WEST SUSSEX COUNTY COUNCIL CONSULTATION

TO:	Arun District Council FAO: Andrew Wood
FROM:	Highways, WSCC: Tim Townsend
DATE:	25th March 2019
LOCATION:	Former Windroos Nursery, Worthing Road, Littlehampton, BN17 6LY
SUBJECT:	LU/25/19/DOC Approval of details reserved by condition imposed on planning reference LU/229/10 relating to Condition 11 - Vehicle Swept Path, Adoption and CMS.
DATE OF SITE VISIT:	
RECOMMENDATION:	☒ Advice ☐ Objection ☐ Modification ☐ No Objection ☐ More Information ☐ Refusal
S106 CONTRIBUTION TOTAL:	£(N/A for purposes of this application)

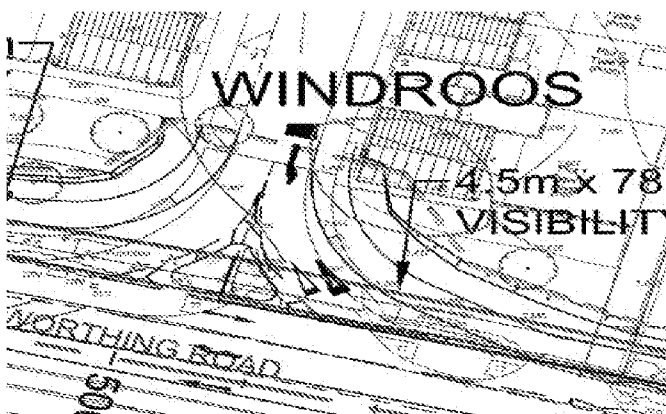
Adoption – Like the comments made above, the applicant should confirm what plan is the correct one showing extent of proposed road adoption. When received, the CHA

will provide further comments. Likewise, comments about the materials proposed will also be made once the correct plan is provided. Street lighting specification does not appear to be available at the time of writing. This too should be submitted. Also see comments under 'other matters' found below.

This is now shown on drawing's 063.5001.004 Rev. 'C' (Preliminary S38 Arrangement) and 'D' (Indicative extent of highway adoption) - both produced by Paul Basham Associates. Both are considered suitable from the CHA's point of view for this DOC application. Material specification, drainage, landscaping and street lighting assessment will be done as part of the S38 checking process post-planning. A decision as to whether the path in the bottom south-western corner of the layout leading from the development to the A259 would be eligible for adoption will be made at the S38 stage.
